PERMIT

SEWAGE DISPOSAL SYSTEM

HOWARD COUNTY HEALTH DEPARTMENT
BUREAU OF ENVIRONMENTAL HEALTH
410-313-2640

SUBDIVISION Country Farm Lane LOT NUMBER 5 ADDRESS 7441 Mink Hollow Road

LOT 5

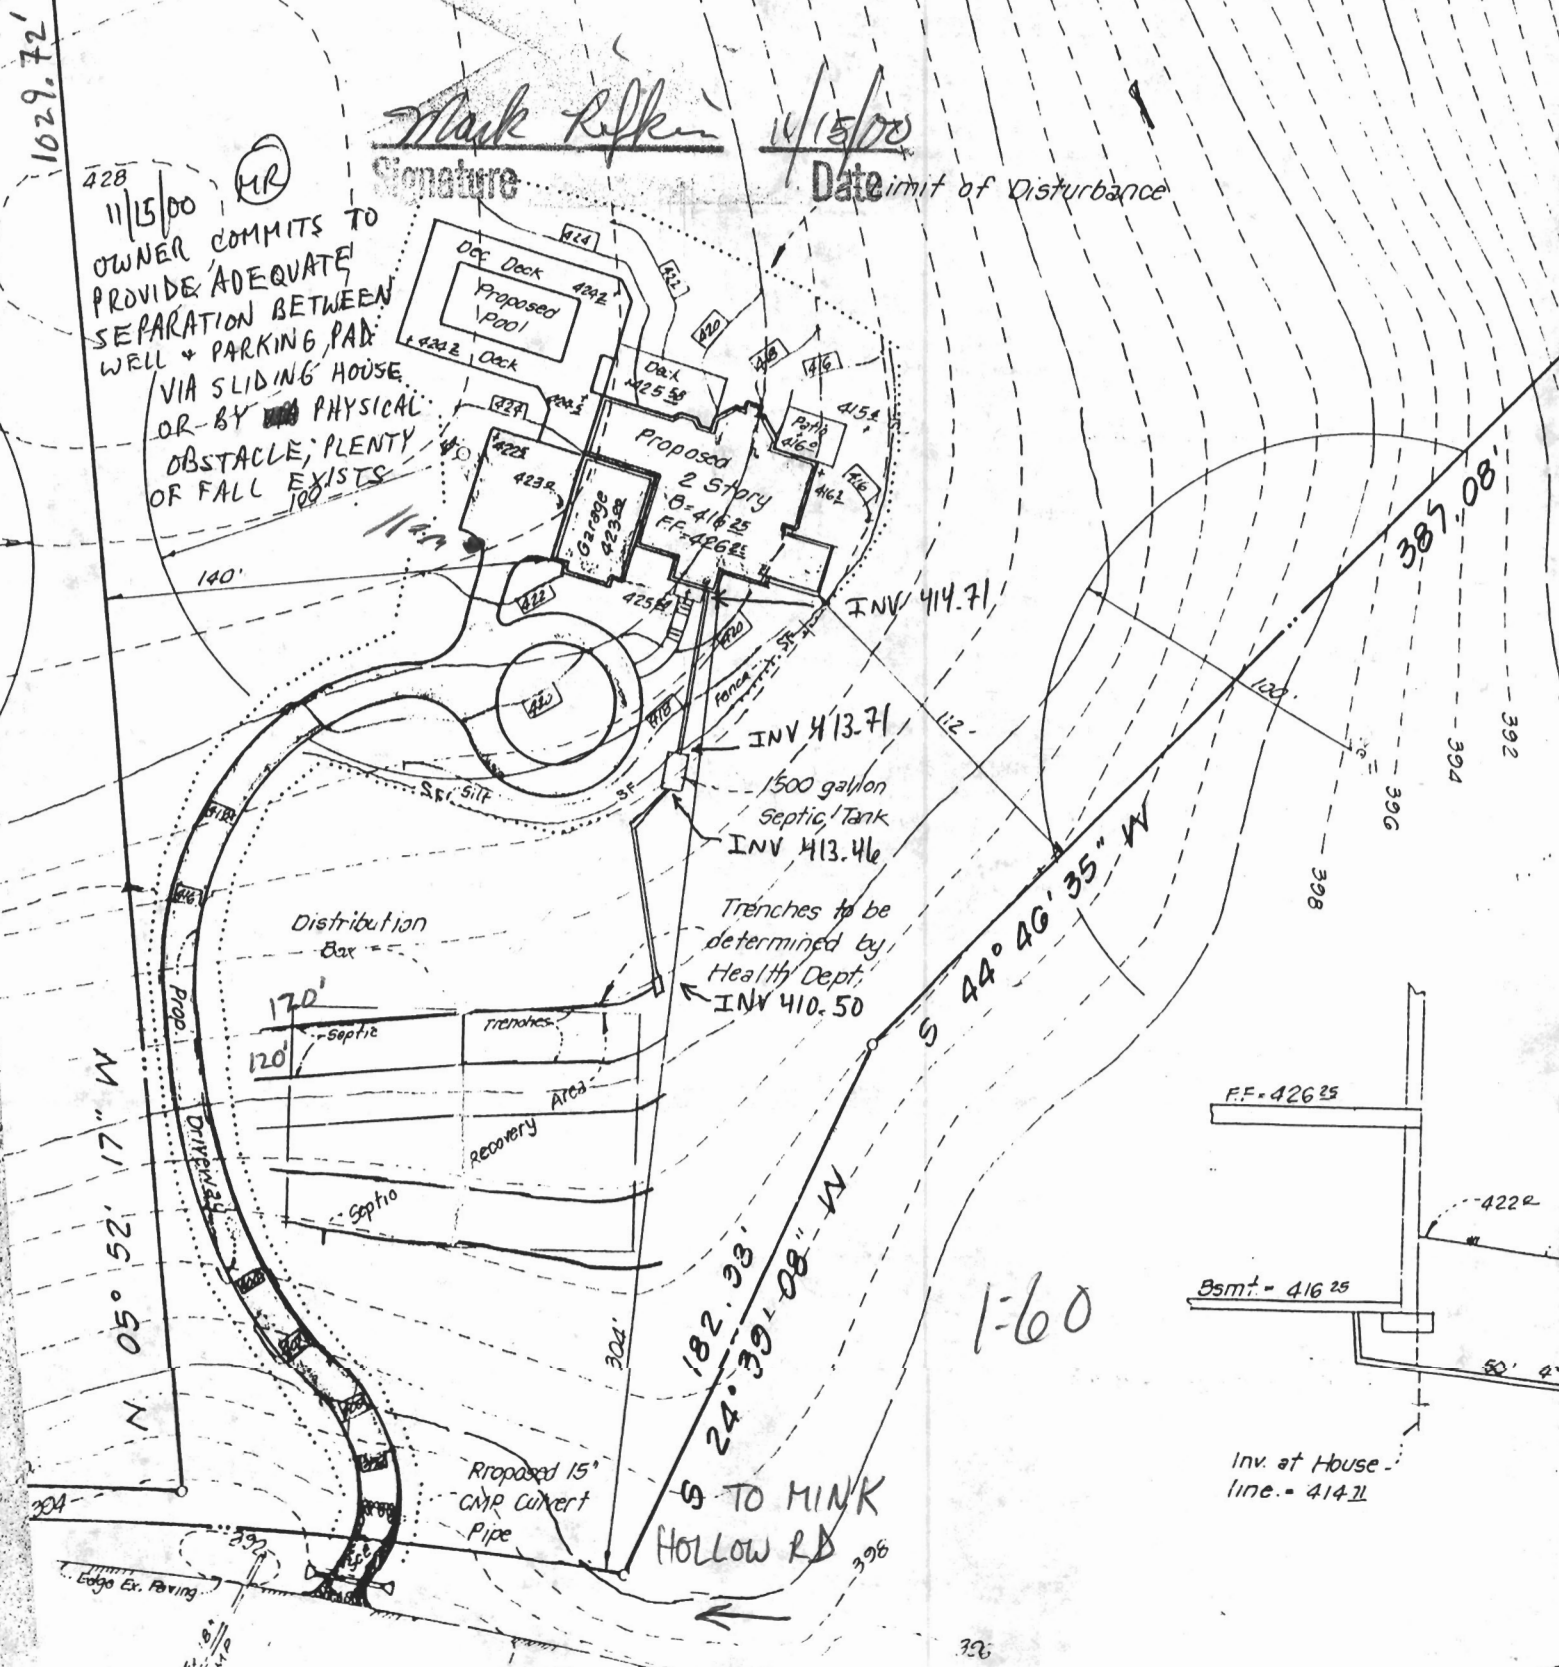
INSPECTION COMMENTS: 5/31/01 First Trench started, Tank and D.B. weren't delivered, but location measurements were taken. (BB) 6/1/01 - OK TO COVER ALL WORK - (SRK)

Approved Septic System Plan
Howard County Health Department

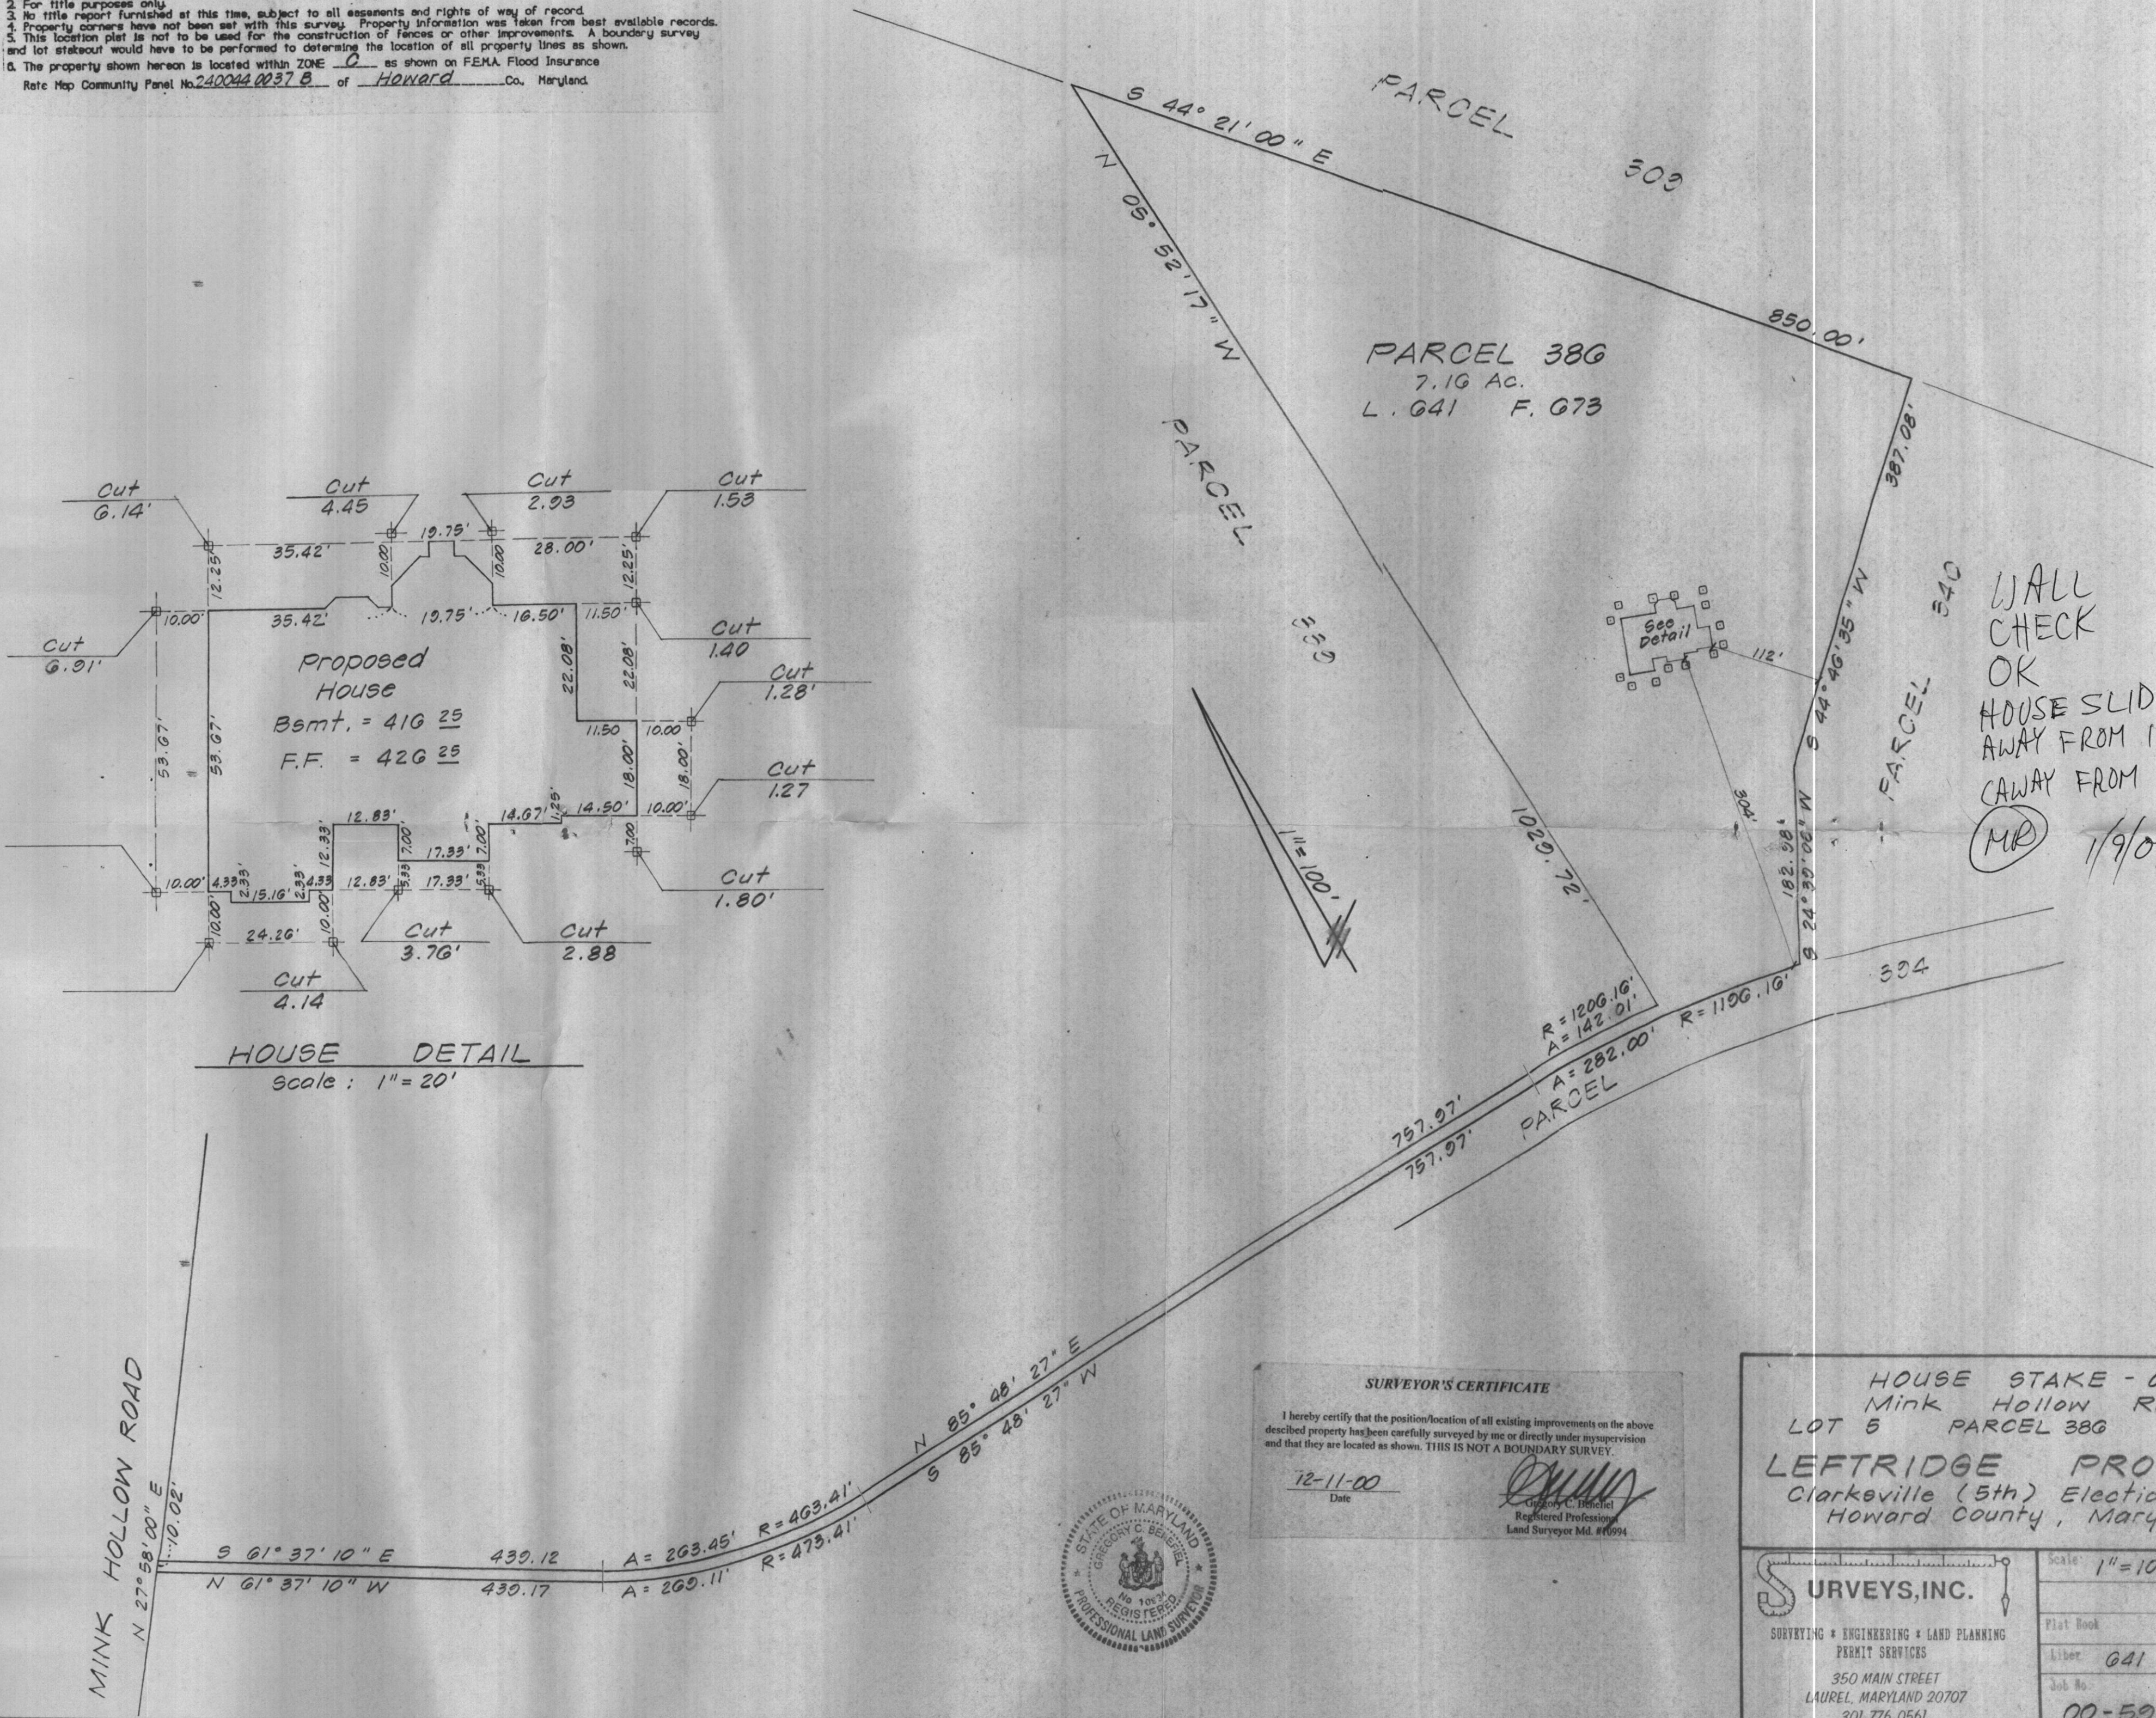
428
11/15/00
OWNER COMMITS TO PROVIDE ADEQUATE SEPARATION BETWEEN WELL + PARKING PAD VIA SLIDING HOUSE OR BY PHYSICAL OBSTACLE; PLENTY OF FALL EXISTS

HOUSE STAKE - OUT
 Mink Hollow Road
 LOT 5 PARCEL 388 TAX MAP 40
LEFRIDGE PROPERTY
 Clarkeville (5th) Election District
 Howard County, Maryland

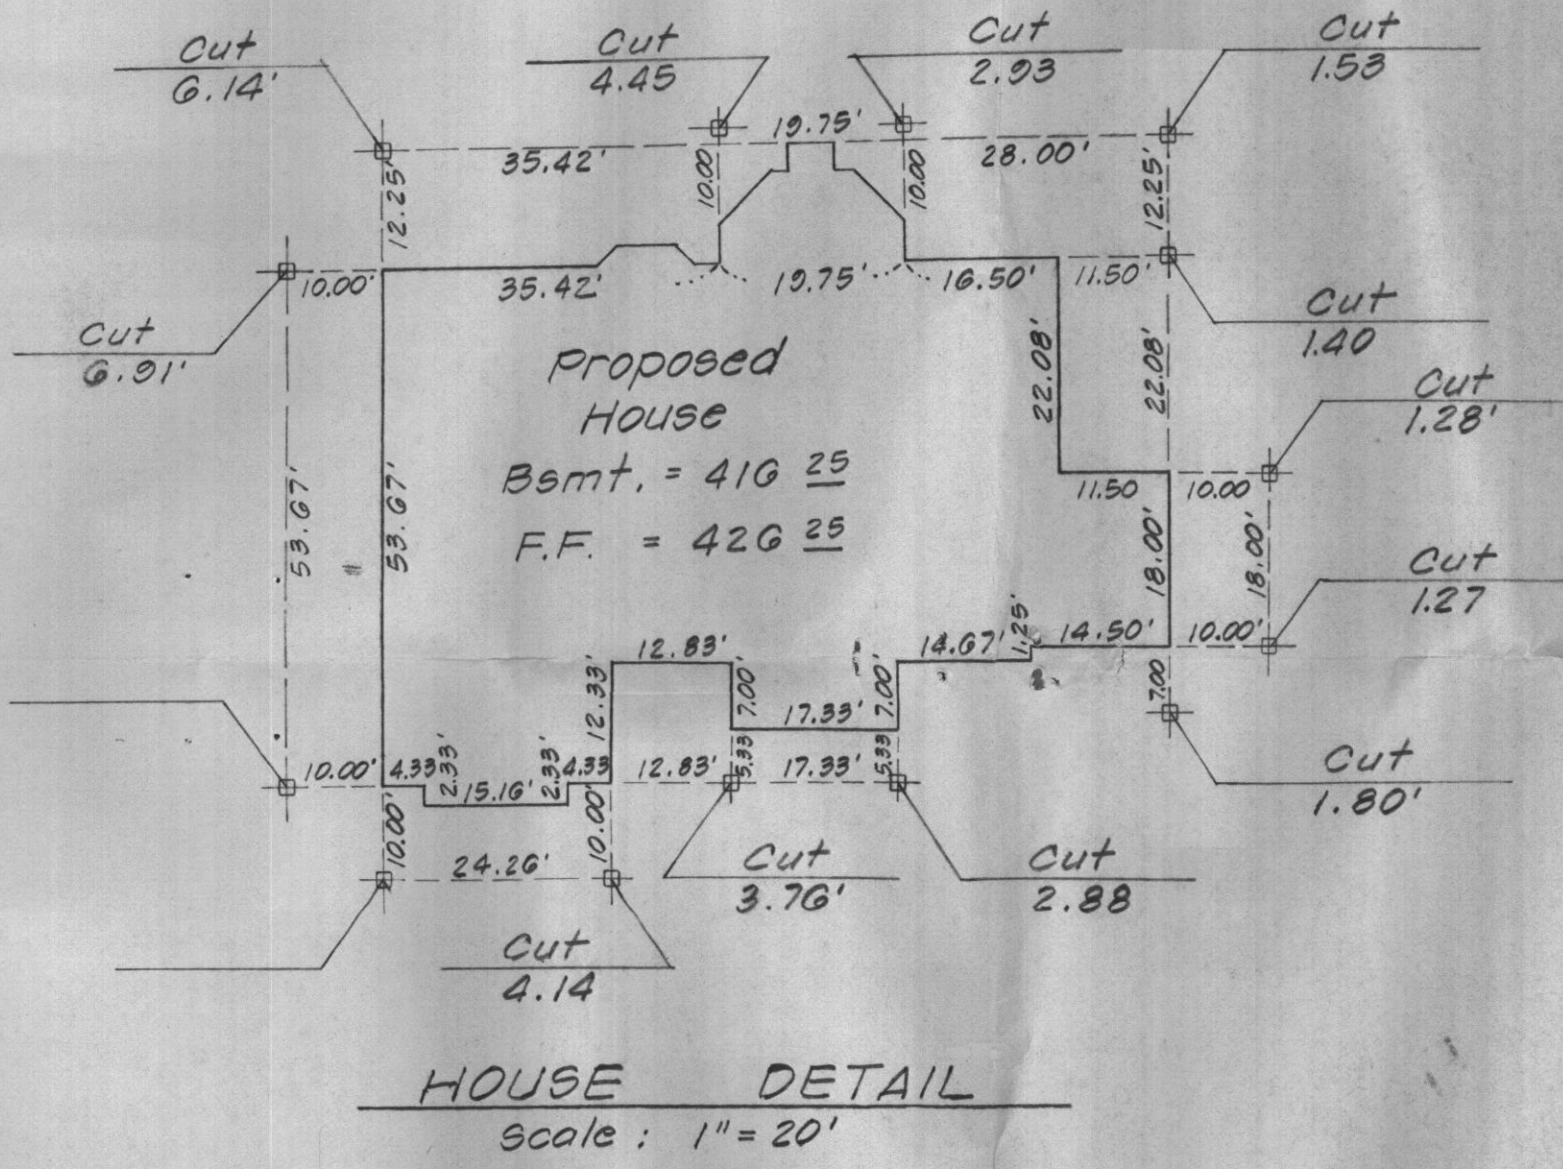
WALL CHECK OK
 HOUSE SLID ~5'
 AWAY FROM 1029.72 LOT LINE
 (AWAY FROM WELL)
 MR 1/9/07
